Appendix M1
Design Quality Audit

Kimmage to City Centre Core
Bus Corridor

Quality Audit

A.2.1 Insufficient Floating Island Width

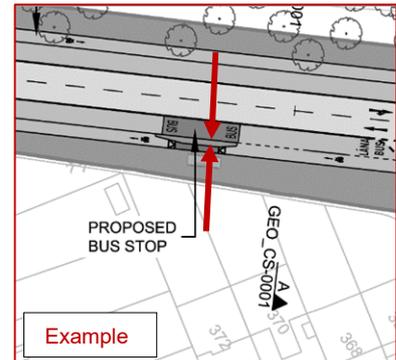
The width of the floating islands at bus stops within the scheme is not indicated on the drawings provided, however, they appear to be narrow.

Should pedestrians waiting for a bus, particularly wheelchair users, choose to wait within the islands, there is a possibility that these would not be able to accommodate the passenger volumes.

Ensure the floating islands at bus stops along the route can accommodate pedestrians.

A.2.2 Crossing Facilities

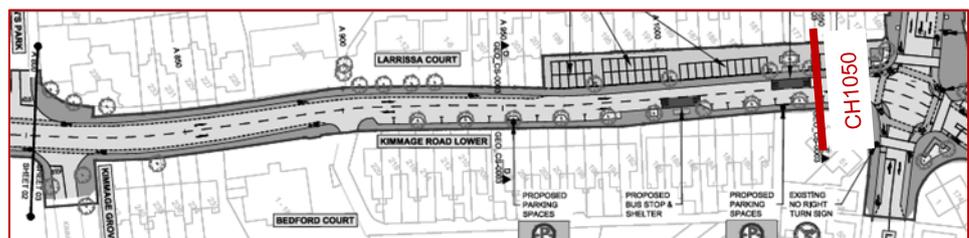
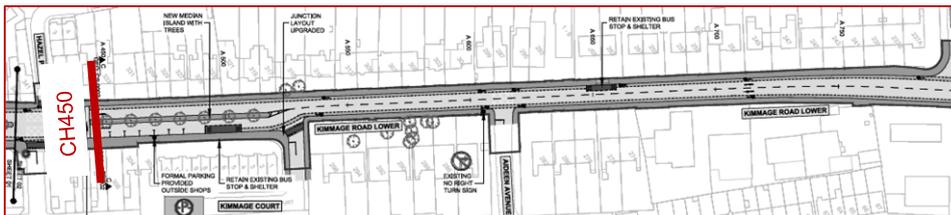
No crossing has been indicated along Kimmage Road Lower between the crossing at Chainage 450 and the junction with Sundrive Road at Chainage 1050. This is a particular concern for mobility and visually impaired pedestrians who would be required to travel a long distance to access bus stops, or amenities, on the opposite side of the road.

In addition, bus passengers accessing opposing bus stops on their return journey would be unlikely to travel to either of these crossings as their desire line would be the shortest route across Kimmage Road Lower.

Identify desire lines across Kimmage Road Lower and provide crossing facilities to support access between the origins and destinations

A.2.3 Tactile Paving Provision

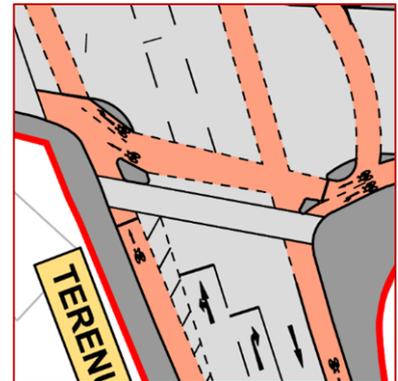
While tactile paving has not been indicated at this early stage in the design process, it will be required at all controlled & uncontrolled pedestrian crossings, and also at the interface between segregated pedestrian/cyclist facilities and shared surfaces, for example the shared surface which extends out to the “floating island” bus stop arrangements.

A lack of tactile paving within the scheme would lead to difficulties for the visually impaired in locating pedestrian crossings and being advised of transitions between shared, and segregated, facilities.

Appropriate tactile paving should be provided at all controlled & uncontrolled pedestrian crossings, and also at the interface between segregated pedestrian/cyclist facilities and shared surfaces.

In addition, measures will be required at the proposed “floating island” bus stop arrangements to ensure that visually impaired public transport users are guided safely to/from the bus stop and the adjacent footpath.

A.2.6 Signal time during pedestrian phases

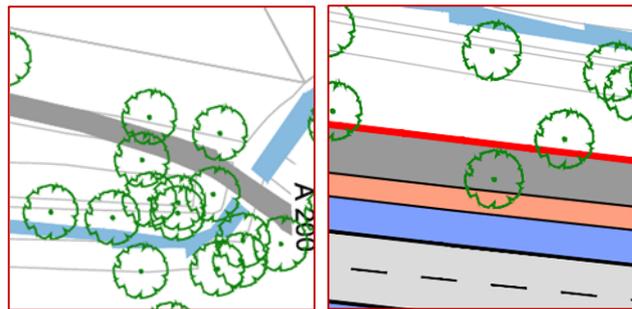
Information regarding the signal timings have not been provided to the Audit Team and it is therefore unclear if sufficient time will be allocated to the pedestrian phases at all crossings within the scheme for a mobility impaired/elderly pedestrian to complete the crossing during the allocated time.

Ensure sufficient time is provided during the pedestrian phase such that mobility impaired/elderly pedestrians can complete the crossing at all locations within the time provided.

A.2.9 Pedestrian/Shared paths – Mount Argus Park

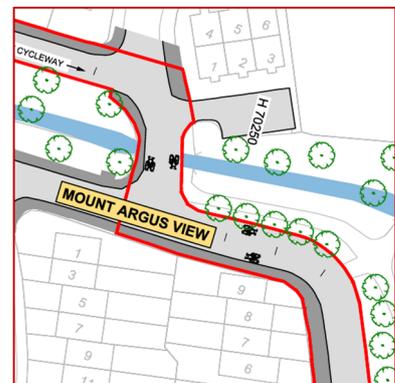
It is proposed to use shared surface areas within poddle cycleway and where it intersects with Mount Argus Park. However, existing footpaths, within the park in many instances will run adjacent to, and cross, the shared path.

The extensive use of shared spaces may lead to difficulties for visually-impaired users who may rely on kerb lines to navigate streets, and it is anticipated that the likely cyclist desire lines to/from the residential areas adjacent to the park will remain creating potential conflict points between cyclists and pedestrians, particularly visually impaired pedestrians, unfamiliar with the shared path arrangement.

Tactile paving treatments should be provided where the shared paths transition to/from segregated surfaces (e.g. at the entrances to the park).

A.2.11 Footpath effective width

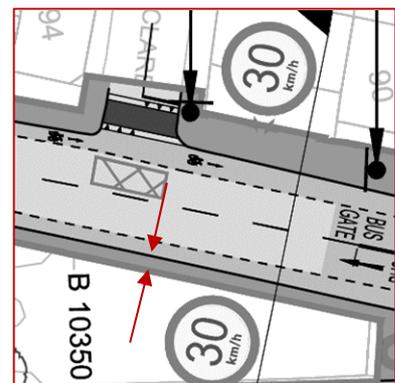
The footpath along the western boundary of Harold's Cross Park appears to be narrow at multiple locations. It is unclear if the footpath width will be sufficient to accommodate mobility impaired pedestrians, particularly wheelchair users or those pushing strollers/prams, travelling within the footpath.

Ensure the effective width of the footpath is sufficient to accommodate all road users.

A.2.12 Connectivity to Parking Spaces

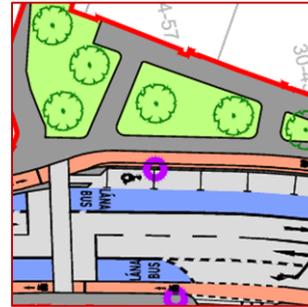
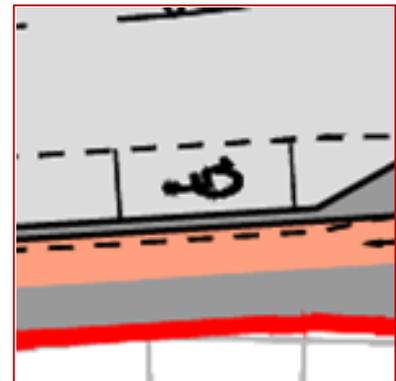
It is proposed to provide on-street parking spaces along the R137 Regional Road.

However, the proposed cycle track runs between the parking spaces and the footpath and there is no link indicated connecting the footpath with the parking spaces. This would result in vehicle occupants having to enter the carriageway or cycle track when accessing these parking spaces.

The proposed parking spaces should connect with the existing footpaths on the adjacent road network to ensure accessibility for vehicle occupants.

B.2.2 Signal time during pedestrian phases

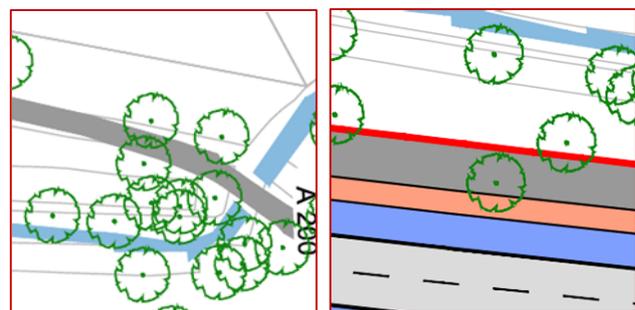
Information regarding the signal timings have not been provided to the Audit Team and it is therefore unclear if sufficient time will be allocated to the pedestrian phases at all crossings within the scheme for a mobility impaired/elderly pedestrian to complete the crossing during the allocated time.

Ensure sufficient time is provided during the pedestrian phase such that mobility impaired/elderly pedestrians can complete the crossing at all locations within the time provided.

B.2.3 Overhanging trees/vegetation along the footpath

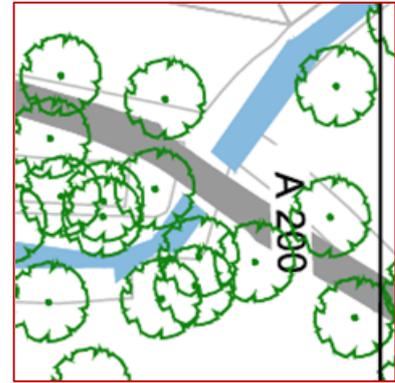
It is unclear from the drawings provided which trees are to be retained, and which are to be removed. A number of trees have been indicated positioned adjacent to the proposed footpath at multiple locations within the scheme which may obstruct pedestrian movements.

Ensure retained/new trees or other items of roadside furniture do not present obstacles/hazards to pedestrians or cyclists.

B.2.6 Pedestrian/Shared paths – Mount Argus Park

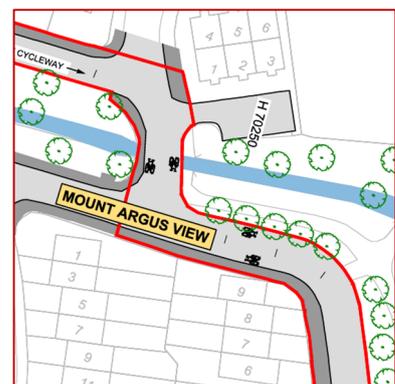
It is proposed to use shared surface areas within poddle cycleway and where it intersects with Mount Argus Park. However, existing footpaths, within the park in many instances will run adjacent to, and cross, the shared path.

The use of shared spaces within the park can lead to difficulties for visually-impaired users who may rely on kerb lines to navigate streets, and it is anticipated that the likely cyclist desire lines to/from the residential areas adjacent the park will remain creating potential conflict points between cyclists and other pedestrians, and visually impaired pedestrians, unfamiliar with the shared path arrangement.

Tactile paving treatments should be provided where the shared paths transition to/from segregated surfaces (e.g. at the entrances to the park).

D.2.1 Offset Cycle Lane

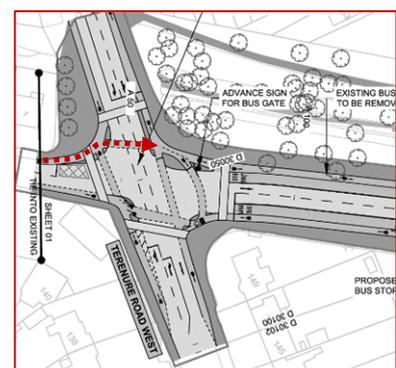
The northbound cycle lane which crosses the Kimmage Road West arm of its junction with Terenure Road West, is offset from the northbound through traffic route. There is a danger that left turning drivers onto Kimmage Road West at this junction may misinterpret the cycle crossing as a separate, downstream, non-motorised road user (NMU) crossing and that they have priority over cyclists wishing to proceed northbound, resulting in possible vehicular/cyclist conflict points.

During the design development the alignment of the northbound cycle lane should be amended to reduce the lateral displacement from the northbound traffic lane, in order to reduce the impression that this is a separate crossing. In addition, left turning drivers should be presented with a flashing left-arrow amber signal to ensure they enter Kimmage Road West with caution.

D.2.2 Cycle Lane blocked by passengers

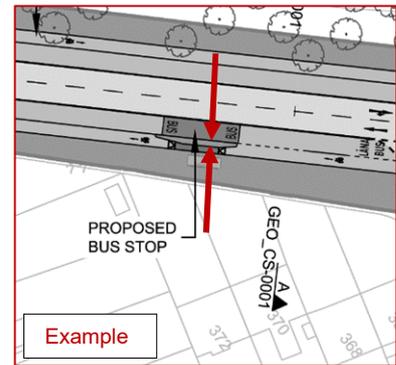
The width of the floating islands at bus stops within the scheme is not indicated on the drawings provided, however, it appears to be narrow.

Should pedestrians waiting for a bus choose to wait within the islands, there is a risk that they could encroach into the cycle track where they would impede cyclists.

Ensure the floating islands at bus stops throughout the route can accommodate pedestrians such that do not encroach into the cycle track.

D.2.3 Signal Phasing Information - Kimmage Road Lower/Ravensdale Park junction

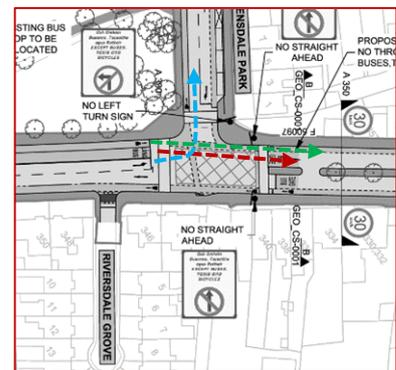
No information has been provided in relation to the proposed signal phasing at the Kimmage Road Lower/Ravensdale Park junction. The junction provides northbound access for buses and cyclists through the bus gate, whilst directing general traffic to turn left into Ravensdale Park.

Should all traffic proceed on the same signal phase, there is an increased risk of conflicts between left turning traffic and straight-ahead buses/cyclists.

Ensure that the general traffic lane operates on a separate signal phase to the bus and cycle lane(s).

D.2.4 Intersection Signalisation- Intersection between Sundrive Road and the Poddle cycleway

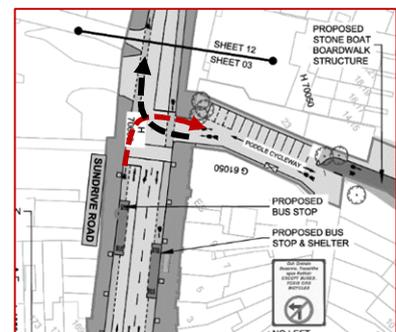
It is unclear if it is intended to signalise the intersection between Sundrive Road and the Poddle cycleway. A failure to signalise this junction could result in difficulties for cyclists entering/exiting the Poddle cycleway, particularly for those undertaking right turns into/out of the cycleway.

The Poddle cycleway access at Mount Argus Way should be incorporated within the signalised junction indicated on Sundrive Road.

D.2.5 Removal of Advisory Cycle Lane

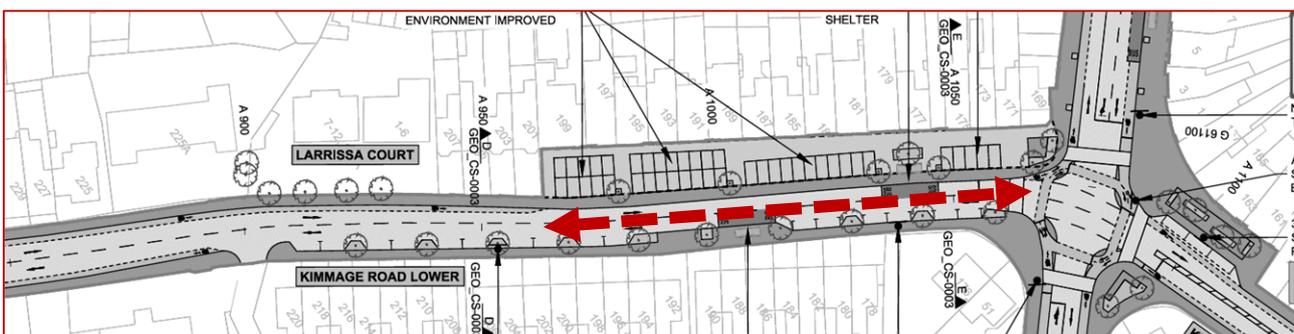
It is proposed to remove a section of an existing advisory cycle lane on either side of Kimmage Road Lower between Sundrive Road and a point 100m to the south. The removal of cycle infrastructure in this area, particularly where significant on and off-street parking exists, may complicate the interaction between drivers and cyclists.

Either: -

- Remove the on-street parking and retain the existing advisory cycle lanes; or
- Provide a shared-surface with traffic calming (e.g. raised tables), surface treatment, signage and road markings to ensure that cyclists and vehicles can safely use the same carriageway.

D.2.6 Cyclist Priority Confusion

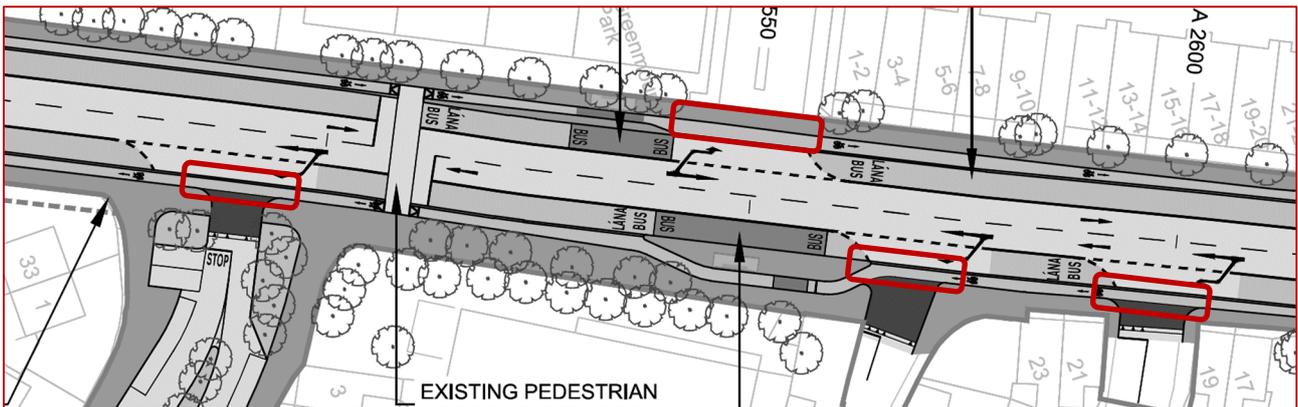
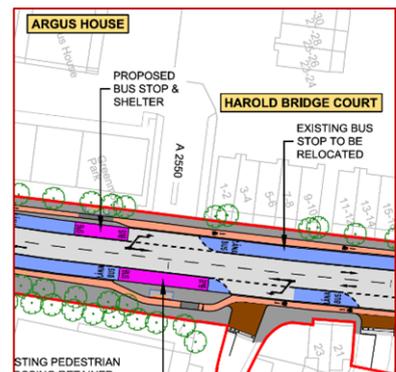
The off-road cycle track is indicated as continuing through side road junctions. Drivers may believe cyclists are on the footpath, so would need to yield to turning drivers on the road. Similarly, cyclists may believe they have priority as the cycle track is continuous across the side road junction. As a result, both cyclists and drivers may be confused as to who has priority at the side road.

The off-road cycle track should be ramped back to the carriageway level upstream of a side road junction and red-coloured surfacing provided within the cycle track at these locations, thereby providing clarity that straight-ahead cyclists have priority at side road junctions.

D.2.8 Cycle Track may be used for loading/unloading operations

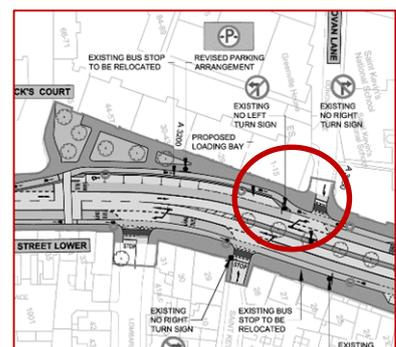
The cycle track is directed behind parking bays and a loading bay at Ch. 3200. Loading/unloading operations could result in the cycle track being impeded, leading to cyclists entering the footpath.

The cycle track should be relocated in front of the parking bays, which is consistent with other cycle track/parking arrangements within the scheme extents.

D.2.12 Overhanging trees/vegetation along the cycle route

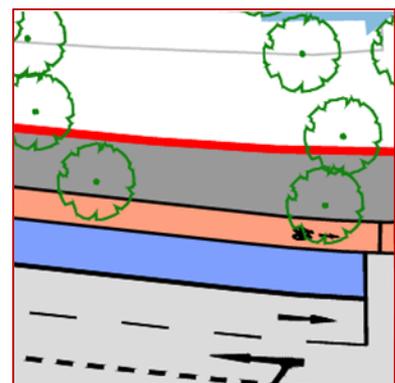
It is unclear from the drawings provided what type of trees/vegetation will be located adjacent to the cycle route. The plan drawings appear to indicate that the tree canopies will encroach into, or overhang, the cycle track.

In addition, the trees/vegetation may shed their leaves in the autumn & winter months which may, in turn, present a slip/skid risk to cyclists using the cycle track.

Ensure appropriate species of trees/vegetation is used that will provide sufficient vertical clearance for cyclists, and require minimal maintenance of the cycle track to keep it clear of leaves/debris.
